**MINUTES
TOWN OF AMHERST
DESIGN ADVISORY BOARD MEETING
January 25, 2024
6:00 PM**

- 1.1. DESIGN REVIEW, SP-2023-14; PROPOSED MIXED-USE BUILDING
Property Located at 5226 & 5228 Main Street
Ellicott Development Company, Petitioner

Re: Major Site Plan Application
Proposed Mixed Use Project - 5226 & 5228 Main Street [SP-2023-14]
Applicant/Project Sponsor: Ellicott Development

A-501

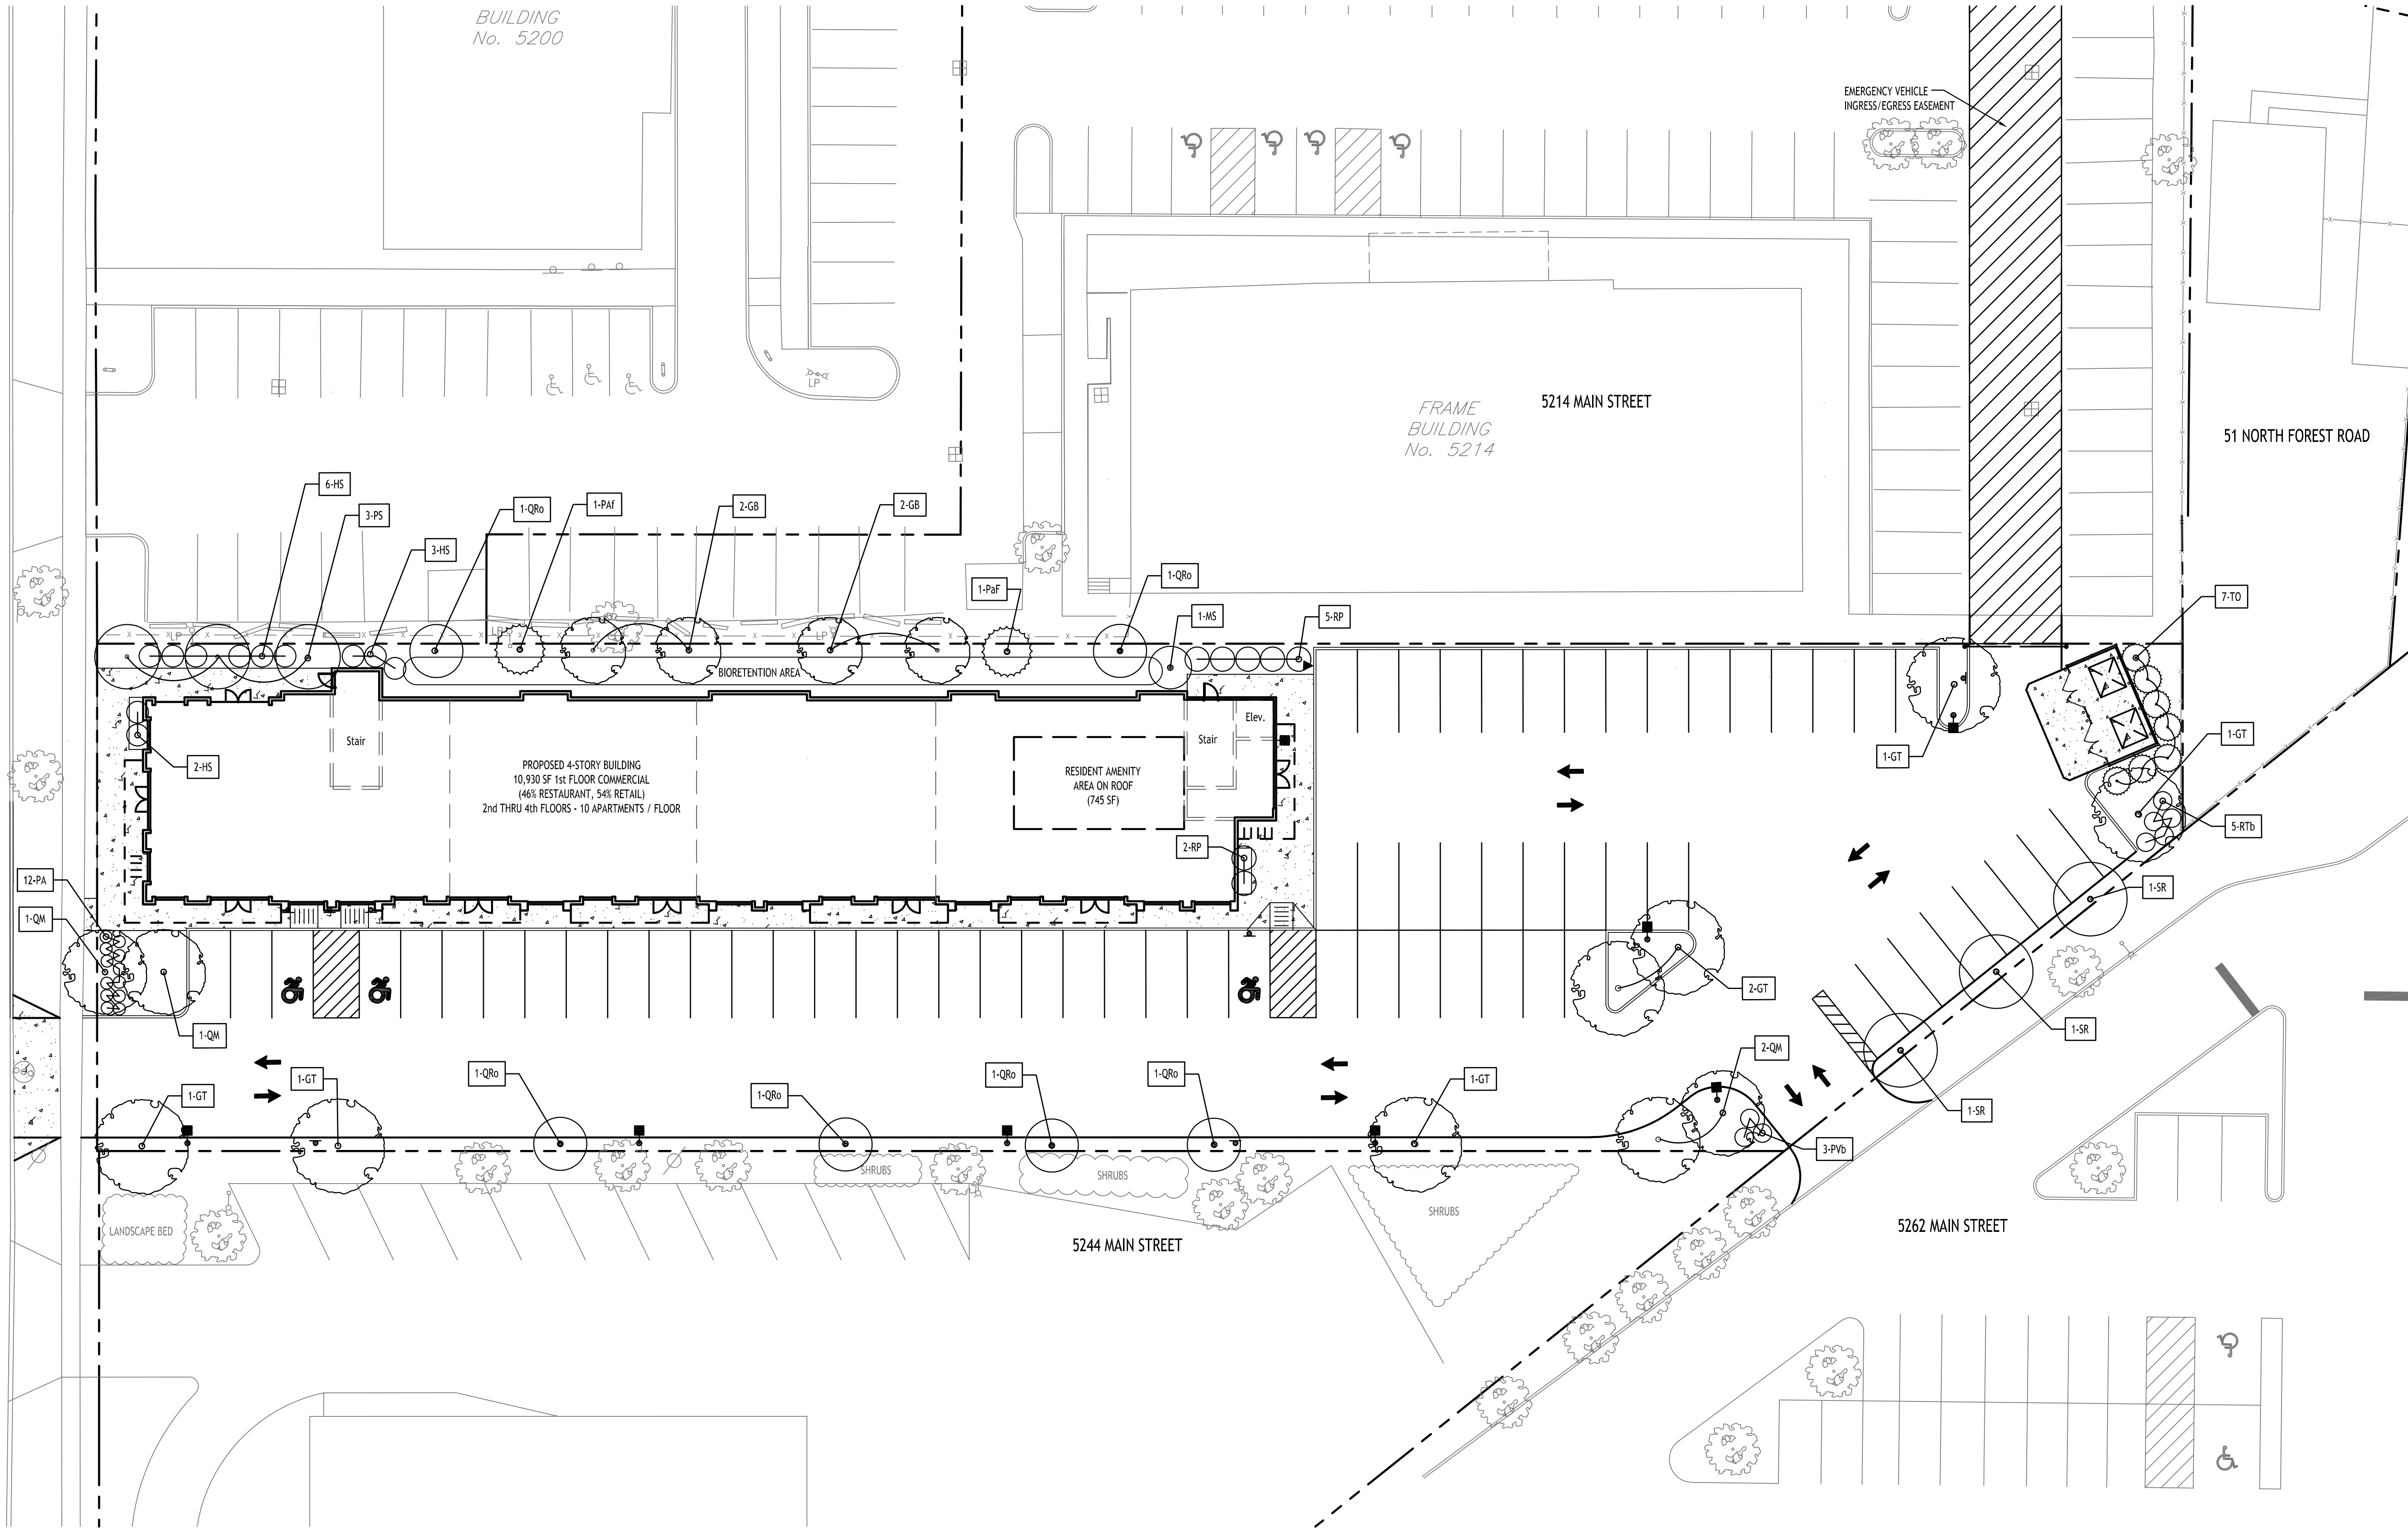
Ms. Conhiser-Uy complimented the addition of the residential entrance onto Main Street but noted the base of the building felt weak due to the large storefronts. She suggested a water table as an example and referenced the photos of the local building. Mr. Sleva stated that the renderings don't highlight how the canopies, which wrap the entire building, help define the base. Mr. Fox explained this was a modern style unlike the building in the photos. He also explained the windows may look bright in the rendering but in reality, they will be transparent and thus much darker.

Mr. Black stated that he appreciated the petitioner's efforts to incorporate their previous statements into the design. He was concerned, however, about the windows and doors starting at the ground, as they will be vulnerable to damage from heavy snowfall and plowing.

Mr. Talty acknowledged the very modern style as seen in the rhythm of the façade but suggested they consider adding an element to contrast the black base. He also asked about outside seating. Mr. Sheedy presented the most updated landscape plan to show there will be seasonal seating on Main Street for customers and residents.

L-100

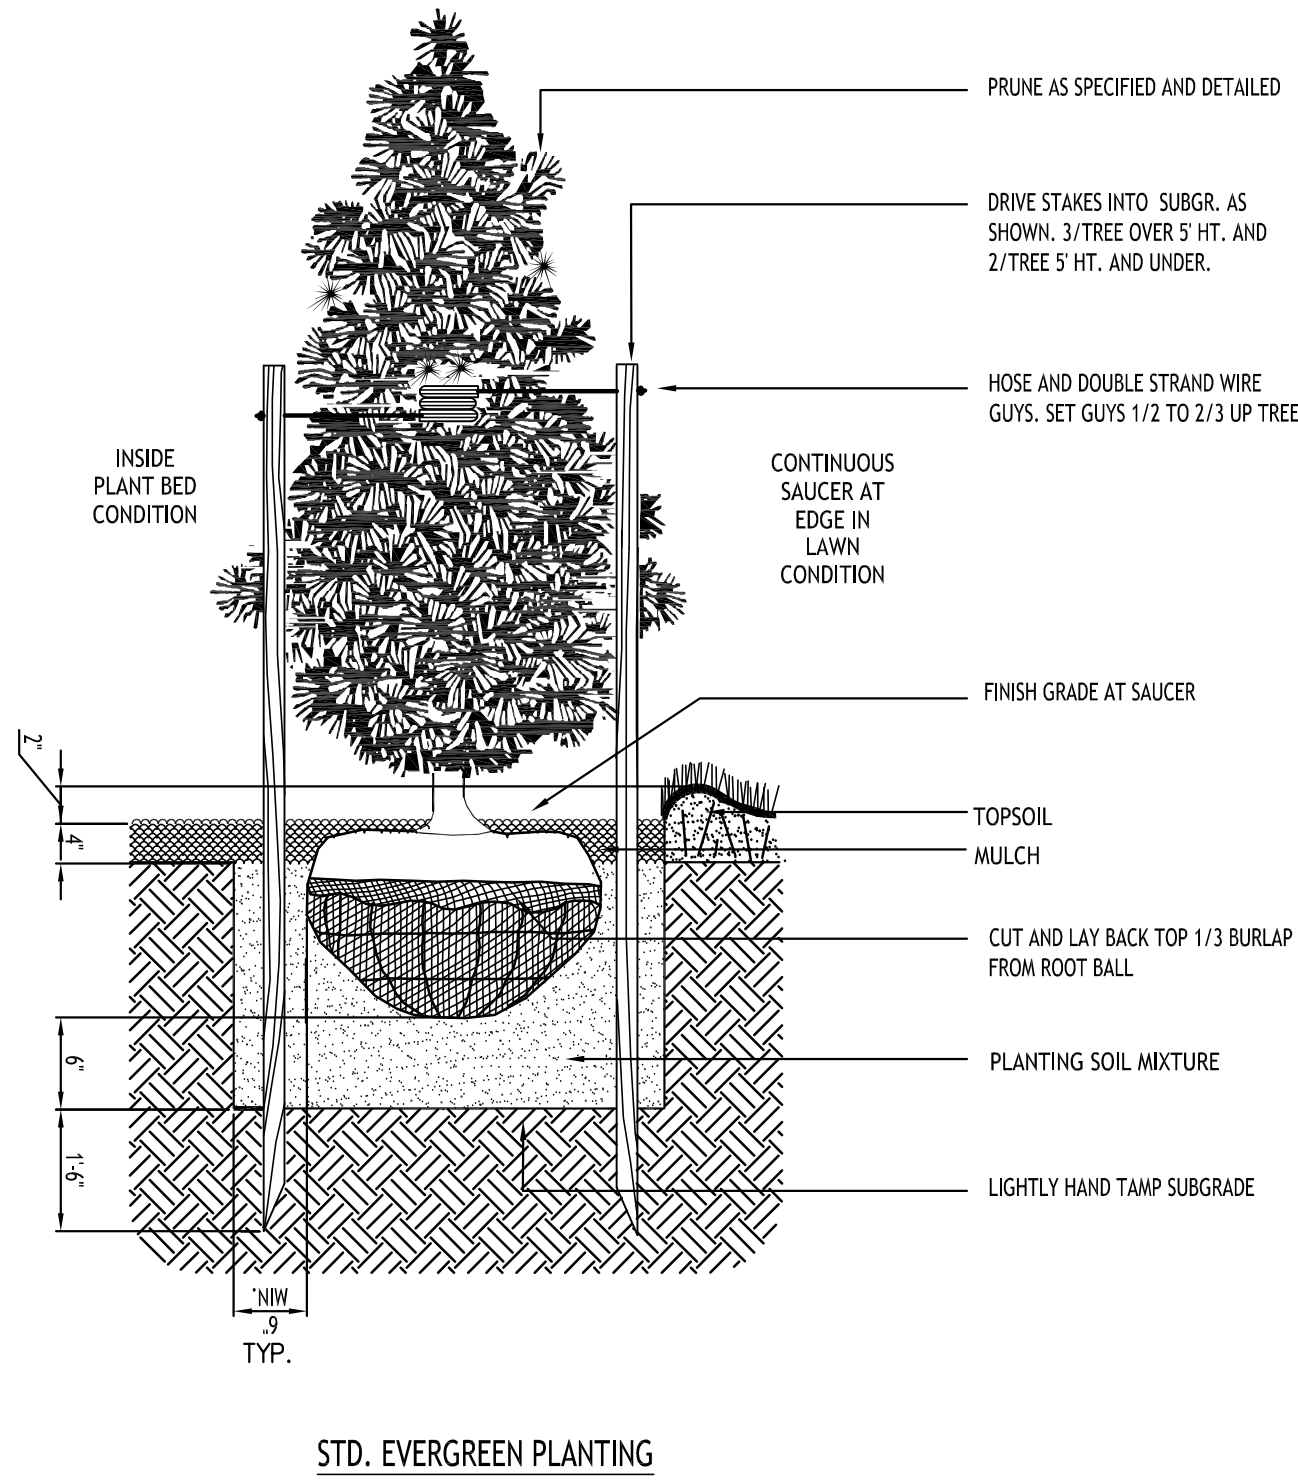
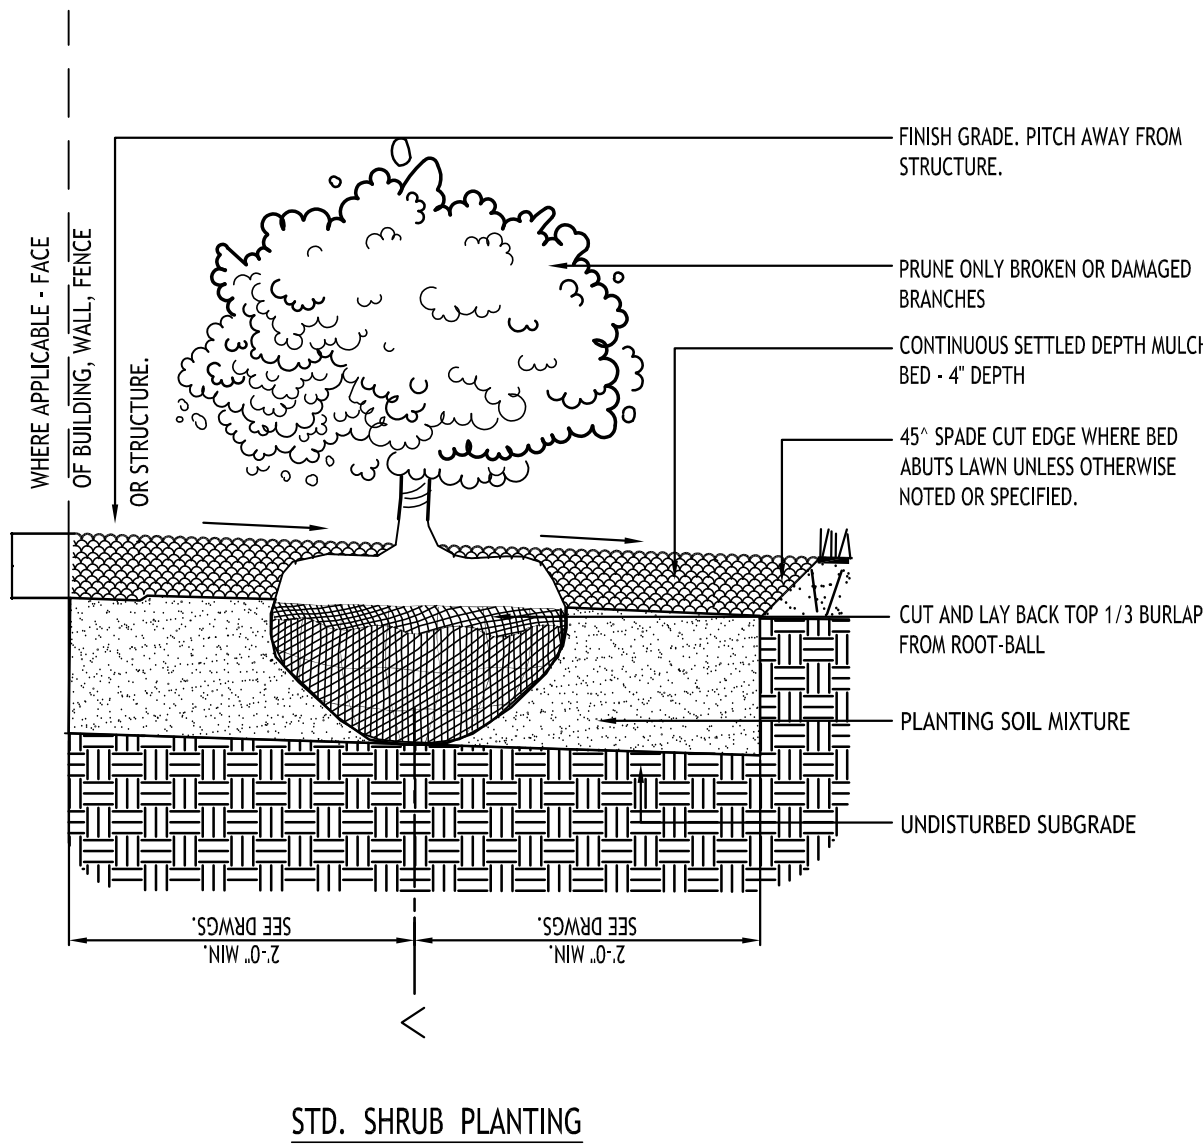
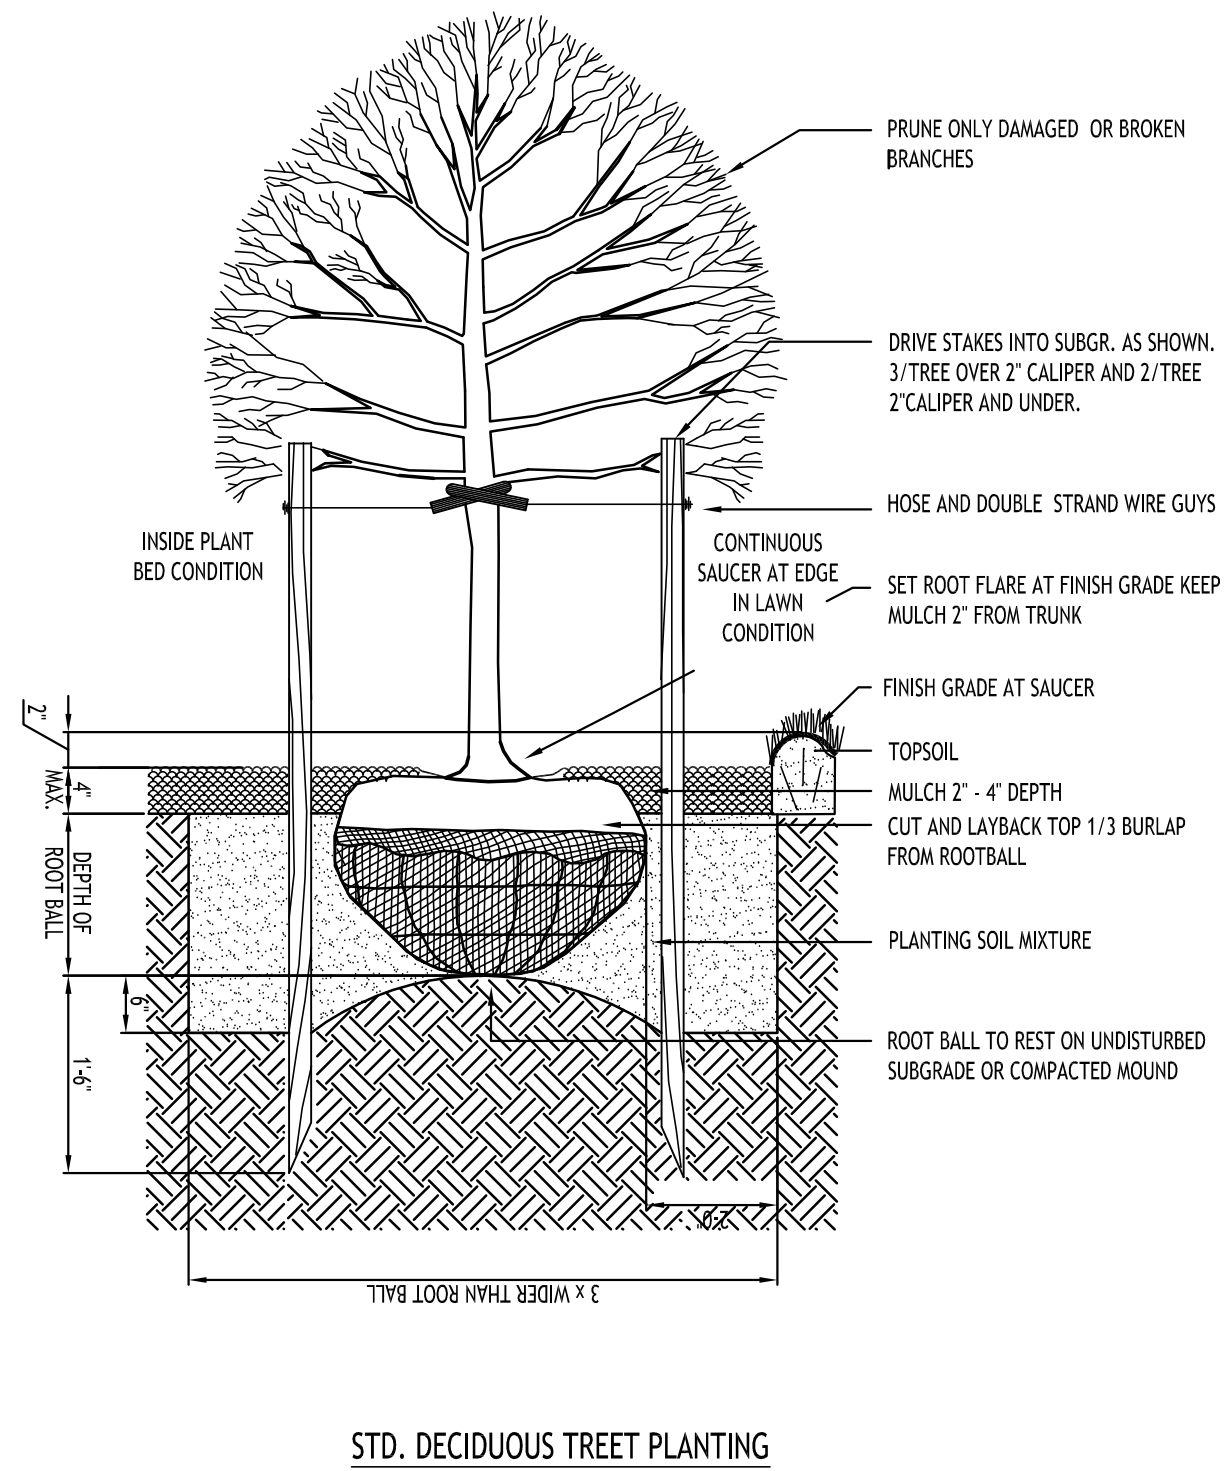
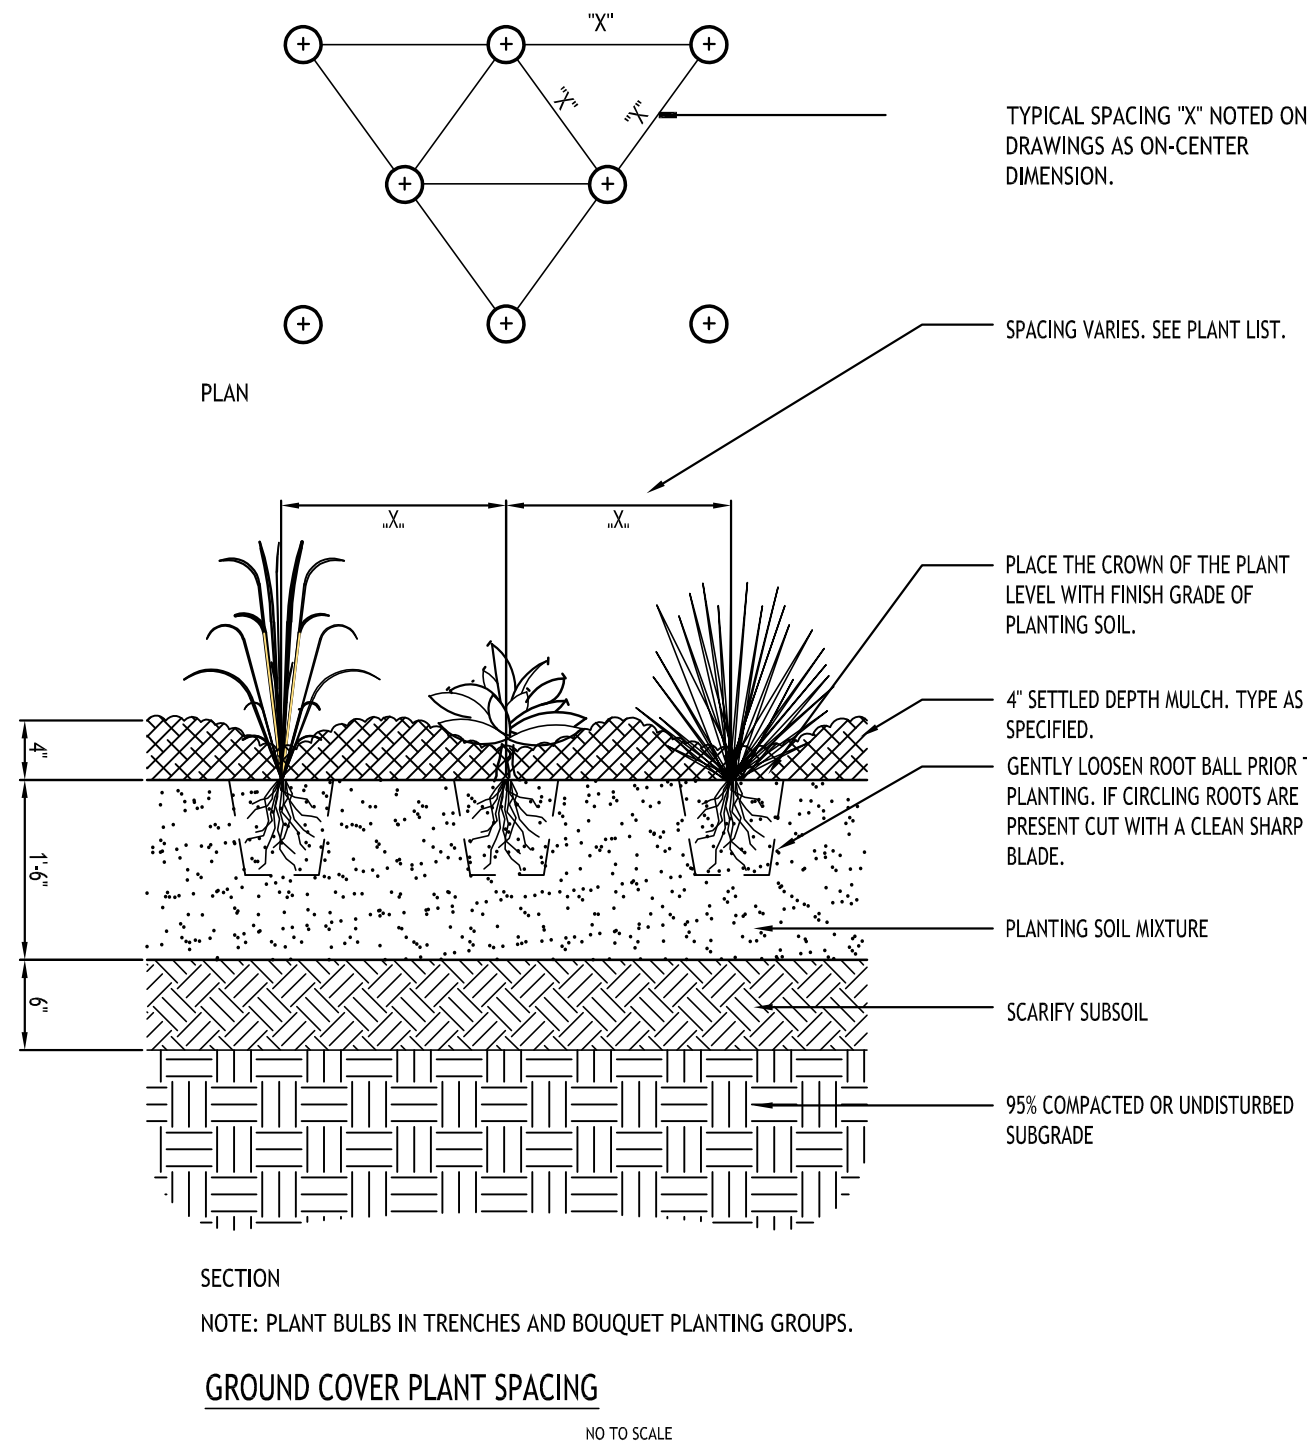
1. *Substitute the maple trees on the plant list on L-100 to another deciduous shade tree species as per the Town of Amherst Community Forestry Management Plan (April 2023). Diversity within plant communities is important for increasing their resistance and resilience to disturbance.*

A-6. Sustainable Features: Please remove the small canopy trees (lilacs, columnar oaks, sargent cherry) and incorporate large mature deciduous shade trees with a 40-50’ wide canopy. Species to consider oaks, lindens, honey locusts, elms, zelkovas, black gum, tulip trees, etc.

Response: Maple trees have been revised to a variety of other large deciduous shade trees as requested.

Response: The small canopy trees are proposed as such because of the narrow width between the proposed pavement area/building and property lines and adjacent neighboring properties. Installing larger growing trees here may result in damage to the pavement, building or neighboring properties pavement when matured.
